RE: DRAINAGE PLAN FOR AN ADDITION TO WALMART STORE #824
(G-19/D4) ENGINEER'S STAMP DATED MAY 23, 1989

GRADING AND DRAINAGE PLAN
WAL-MART STORE # 824 STOCKROOM ADDITION

LA MIRADA SQUARE AS-BUILT GRADING PLAN

RE: DRAINAGE PLAN FOR IMPROVEMENTS TO LA MIRADA SQUARE
(G-19/D4) ENGINEER'S STAMP DATED MAY 18, 1989

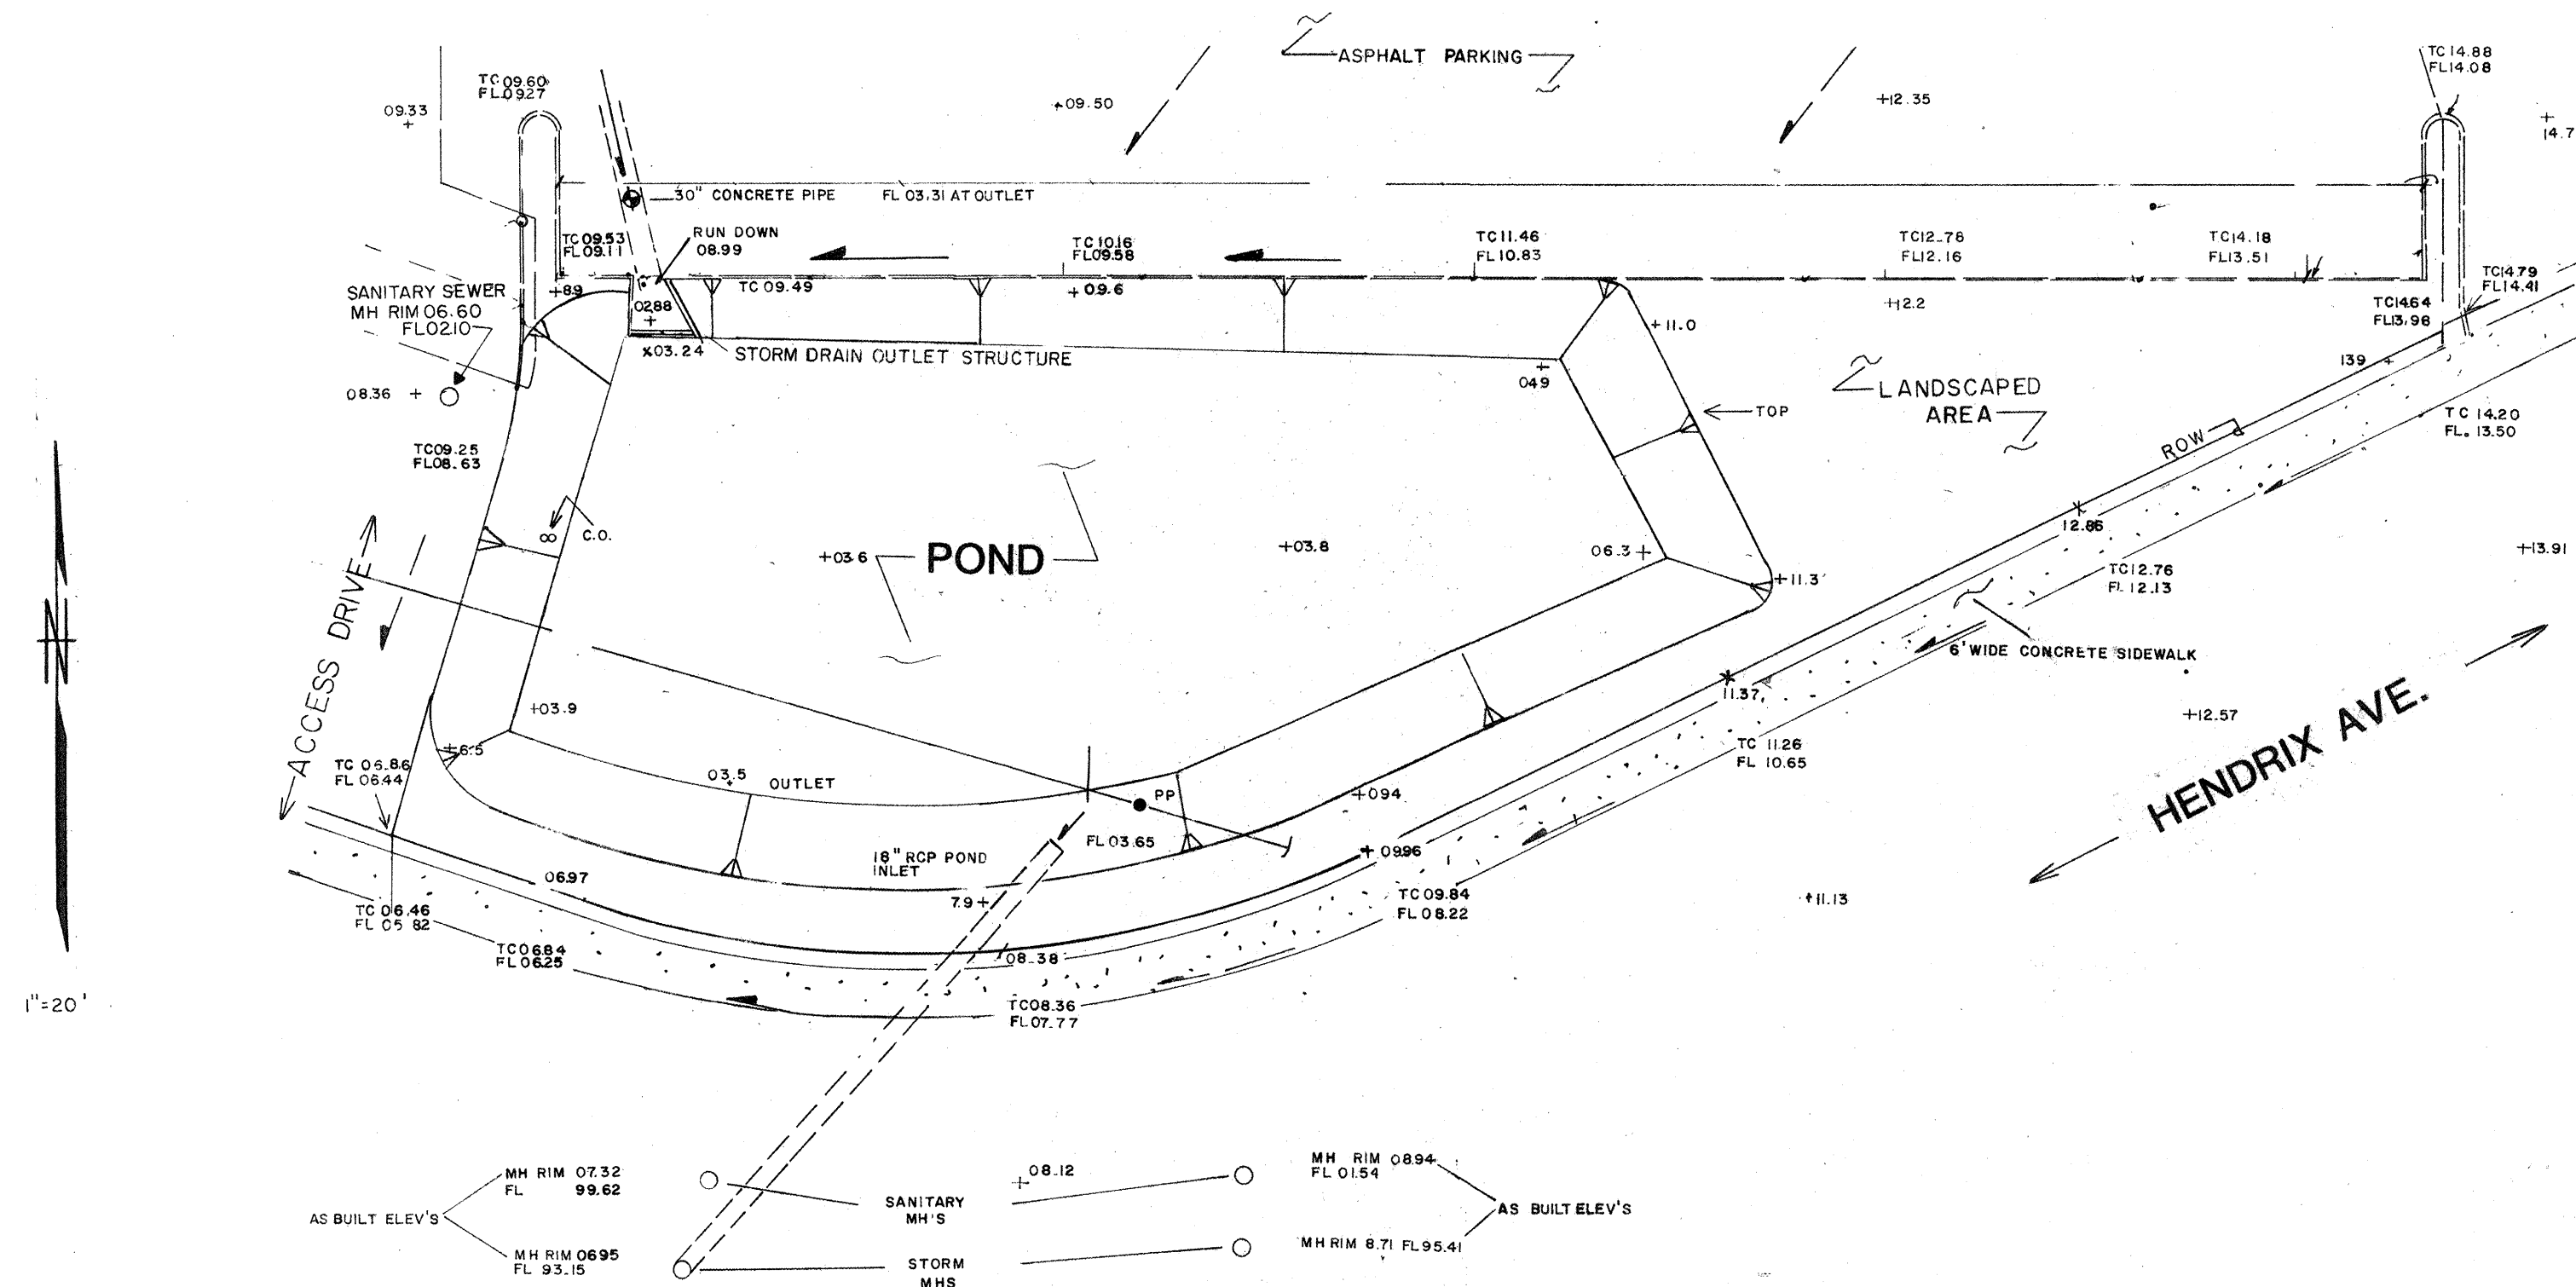
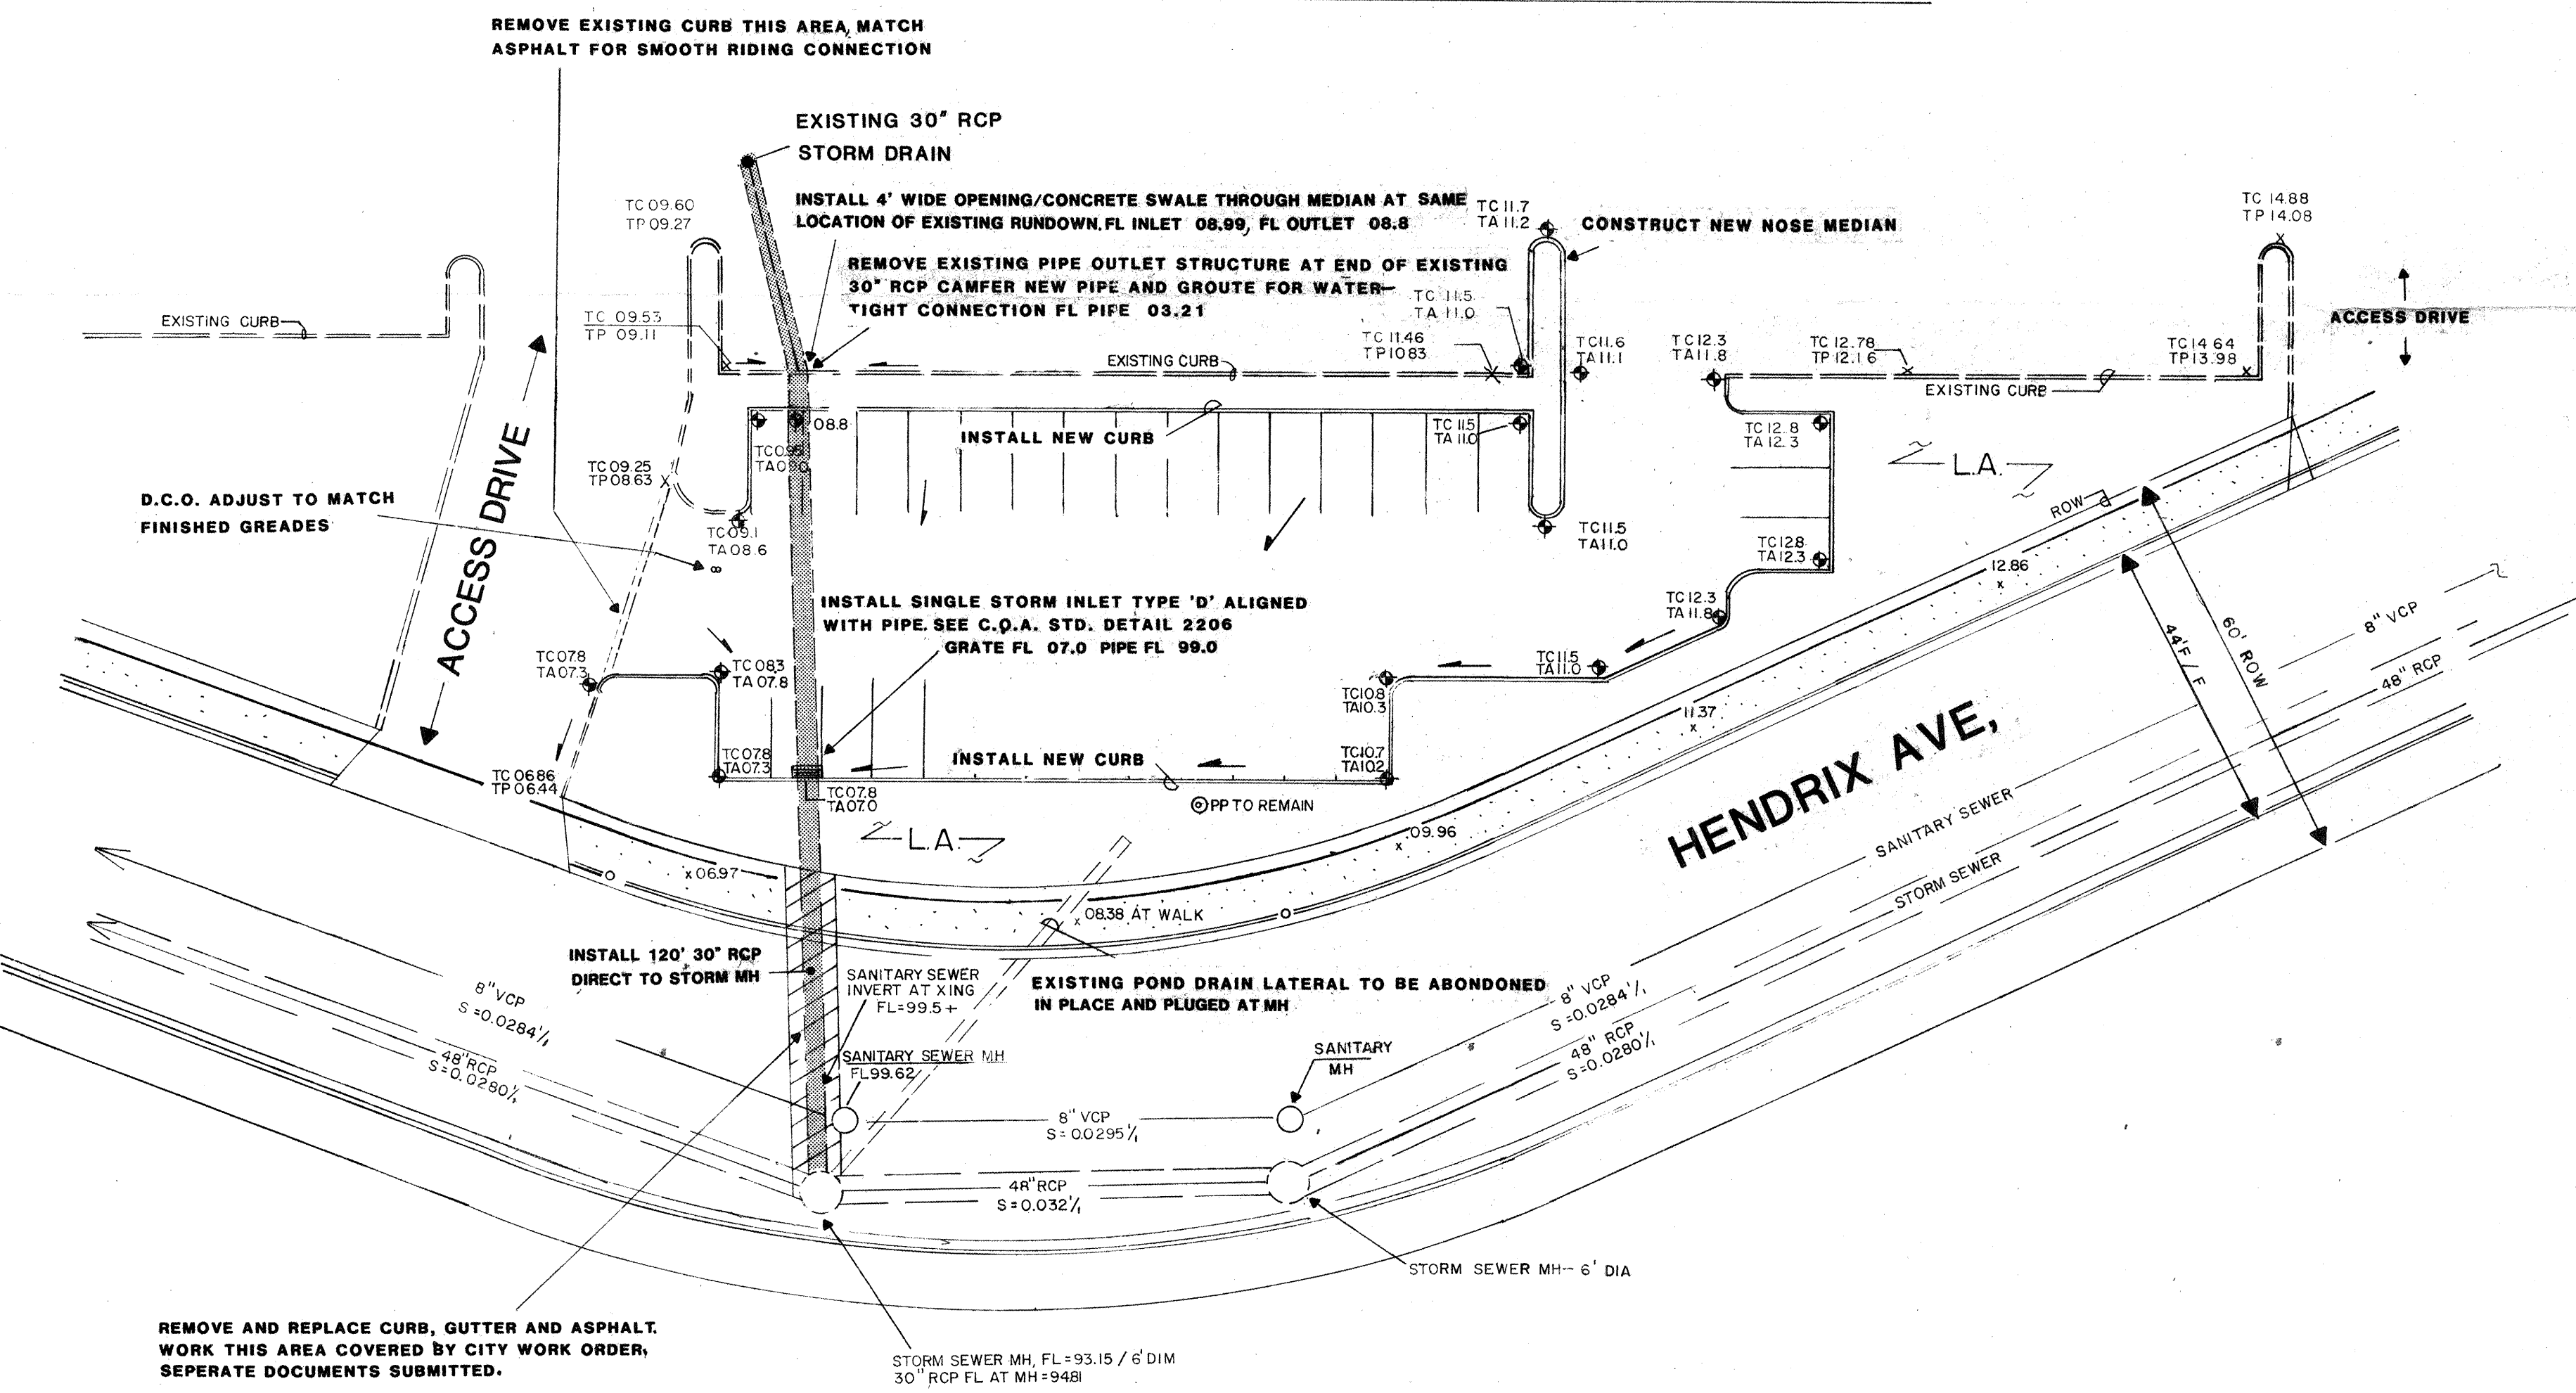
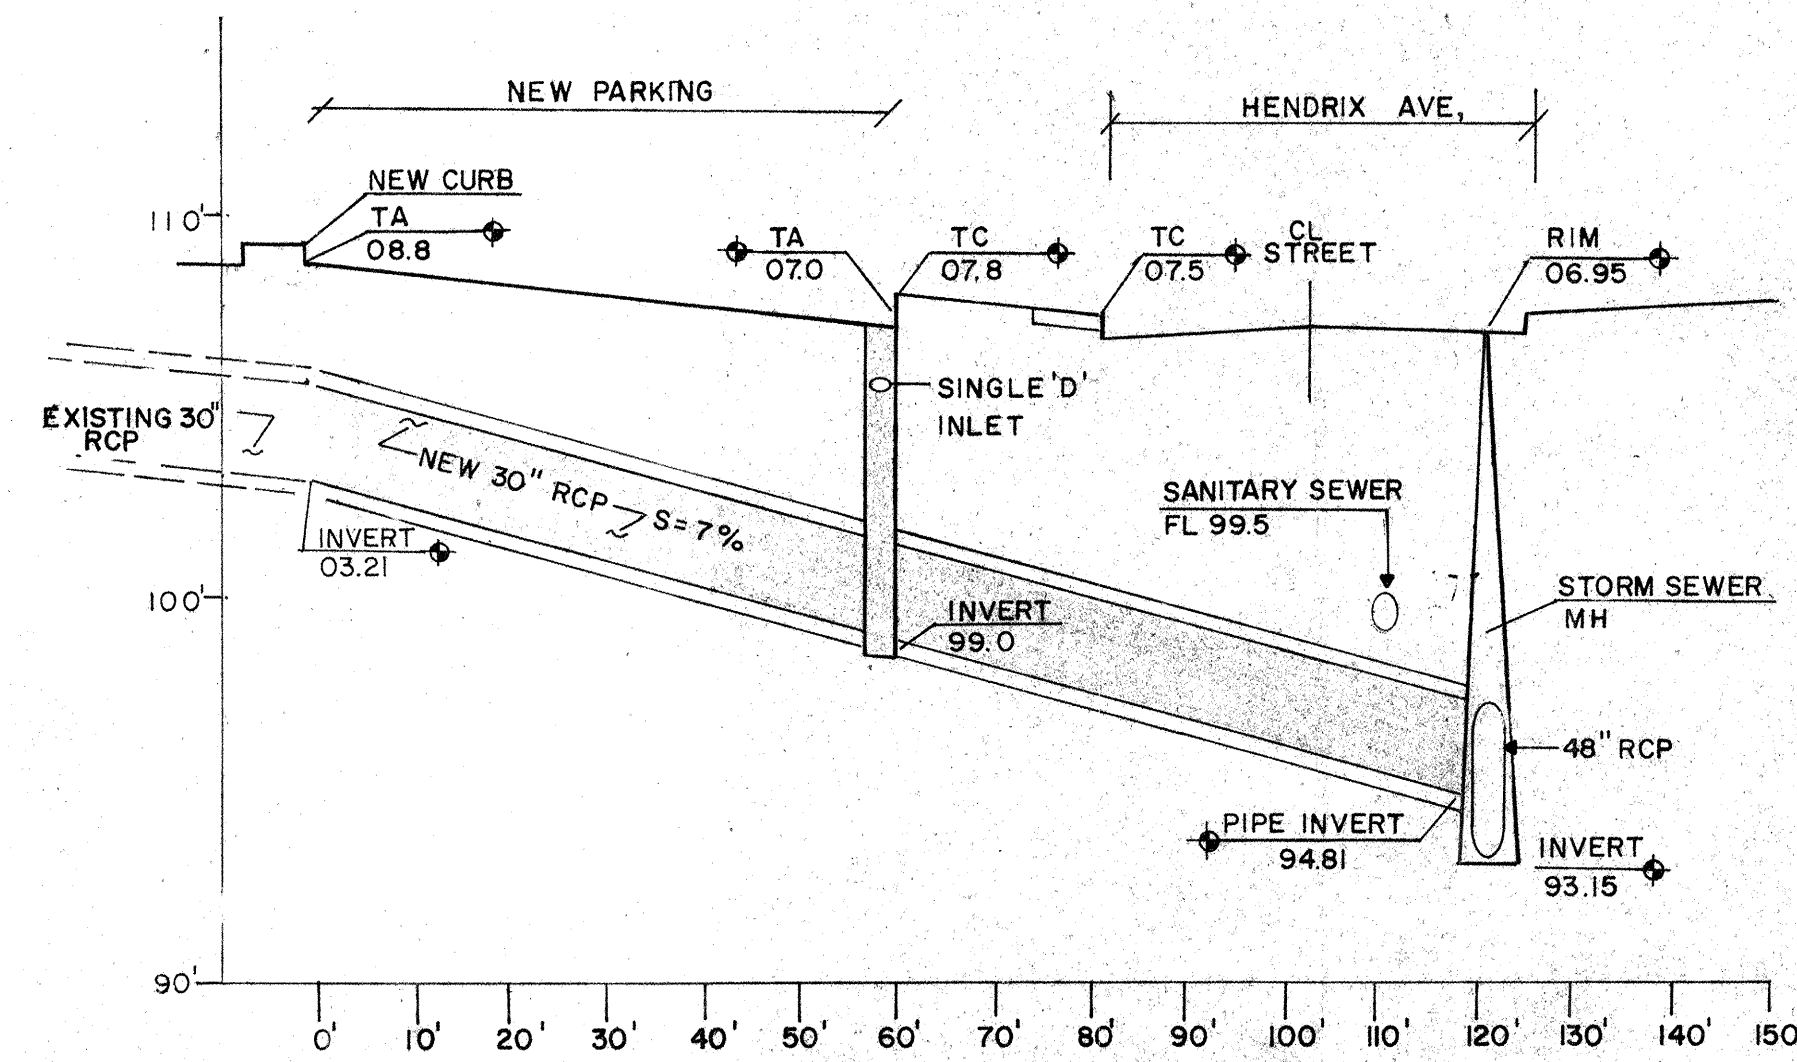
Based on the information provided on your submittal of May 18, 1989, the above referenced plan is approved for Grading/Paving.

Please be advised that the tie-in to the existing storm sewer line must go through work order procedure and be reviewed by D.R.C..
